ADDENDUM NO. 5

PROPOSAL FOR FURNISHING ALL LABOR, MATERIALS, EQUIPMENT, TRANSPORTATION, SUPERVISION, PERMITS, ETC. NECESSARY FOR THE ULL CLECO ALTERNATIVE ENERGY RESEARCH CENTER MICROGRID PROJECT, LOCATED ON THE UL LAFAYETTE CAMPUS-CLECO, IN CROWLEY, LOUISIANA.

Due Thursday October 5, 2023 2:00 PM Solicitation No. 24203

1 Equipment Pad Plan View
S100 1/2" = 1'-0"

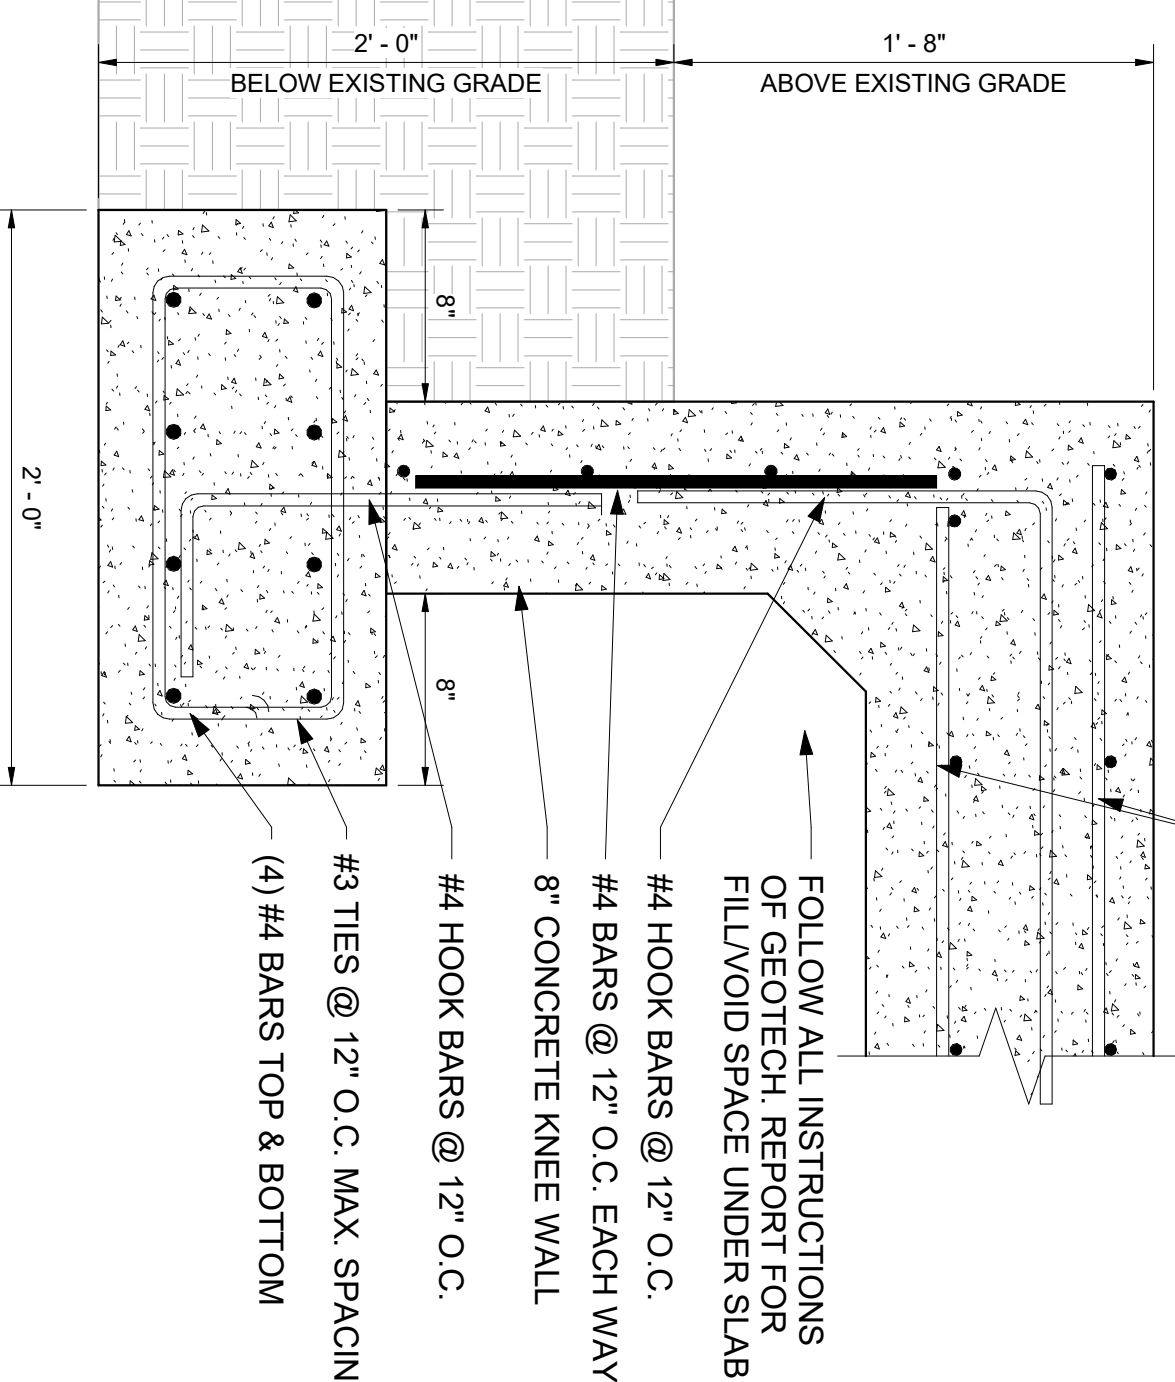
Contractor question:	Department response:
(1) Please advise if more information can be provided on the slab detail in reference to elevation, if fill will be required, and type of rebar or wire mesh required for the equipment rack near the building and the DC combiner box.	Please see updated plan sets.

(3) Please provide more information on the 2" rigid pipe required for the equipment rack near the building.	Please see updated plan sets.
(4) The anchor bolts in the slab for the combiner box are to be hilti anchor bolts or can we just put a galvanized Unistrut in the slab?	Please see updated plan sets.

VERIFY IN FIELD THAT SAND FILL WAS USED 5FT PAST EXTENTS OF BUILDINGS AS STATED IN GEOTECH REPORT. IF SAND FILL IS PRESENT IN THIS LOCATION, EXCAVATION IS NOT REQUIRED BETWEEN SLAB LOCATION AND BUILDINGS

- FOUNDATION AND GROUND FLOOR PLAN NOTES**
1. EXISTING GROUND FLOOR SLAB ELEVATION IS REFERENCED AS DATUM UNLESS NOTED OTHERWISE.
 2. TOP OF PAD ELEVATION IS AT DATUM UNLESS NOTED THIS ON PLAN FROM DATUM.
 3. DENOTES 12" SLAB ON GRADE W/ 2 WAYS OF #4 BARS @ 12" O.C. BOTH WAYS. PLACE BOTTOM MAIN 3" FROM BOTTOM OF SLAB.
 4. COORDINATE ALL NEW AND EXISTING UNDERGROUND UTILITIES WITH FOUNDATIONS AND SUBMIT ALL PROPOSED SLEEVE LOCATIONS TO ARCHITECT FOR REVIEW.
 5. REFER TO STRUCTURAL SPECIFICATIONS, GENERAL NOTES, AND SCHEDULE FOR ALL DIMENSIONS AND CONNECTIONS.
 6. REFER TO PV SHEETS FOR PIPE HEIGHT, STRUT BRACING LOCATIONS AND U-BOLT CONNECTIONS.
 7. FOLLOW ALL HLT MANUFACTURER INSTRUCTIONS AND EDGE DISTANCE REQUIREMENTS FOR ANCHOR BOLTS.
